Work Order ID 98199

Item Name: Crosstube Assembly, Mid Aft

DART AEROSPACE LTD HAWKESBURY, ONTARIO, CANADA		REV. A
DRAWING NO.	D206-667-247	SHEET 1 OF 4
TITLE	CROSSTUBE ASS'Y (206L MID AFT)	SCALE
COPYRIGHT © 2018 BY DART AEROSPACE LTD		NTS

DRAWING NO. D206-667-247	TITLE CROSSTUBE ASS'Y (206L MID AFT)	REV. A	DART AEROSPACE LTD ENGINEERING ORDER	D.E.O. NO. D206-667-247-A-1	SHEET NO. SHEET 1 OF 1	SCALE NTS
DRAWN 92	CHECKED ASS	MFG. APPR. KD	APPROVED JMD	DE APPR. H		
DATE 11.07.15	DATE 11.07.20	DATE 11.07.21	DATE 11/07/21	DATE 11.07.21

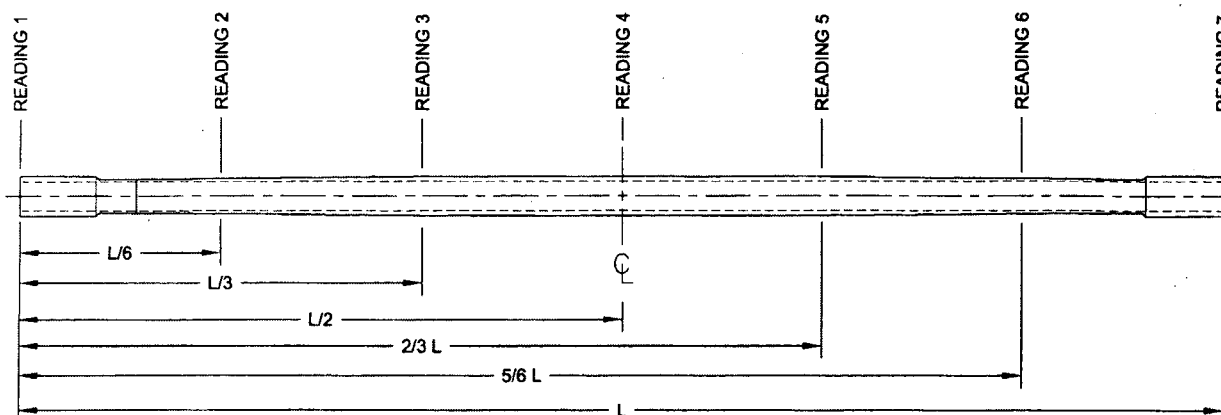
PURPOSE:

REPLACE MAGNOBOND WITH PROSEAL.

NOTE 12 & 15, SHEET 1 IS AMENDED AS FOLLOWS:

IS:

Item	Qty -247	Part Number	Description
9	A/R	PROSEAL 890 B-2	SEALANT, AMS-S-8802 CLASS B-2

IS:

- 12) TO INSTALL D2892-1 SUPPORT: ABRABE MATING SURFACE OF SUPPORT AND CROSSTUBE WITH 180-GRIT SANDPAPER AND REMOVE RESIDUE WITH MEK (OR EQUIVALENT). APPLY A 0.04" TO 0.07" THICK LAYER OF PROSEAL 890 CLASS B-2 (OR AMS-S-8802 CLASS B-2) SEALANT TO MATING SURFACE OF SUPPORT.
- 15) TORQUE CLAMPS 80 TO 100 IN.-LB. ENSURE AT LEAST 1.5 THREADS SHOWING IN SAFETY AND THAT NUT HAS NOT BOTTOMED-OUT AFTER TORQUING. **PRIOR TO PACKAGING, RE-CHECK TORQUE ON CLAMPS AFTER PROSEAL 890 SEALANT HAS CURED FOR 72 HOURS.**
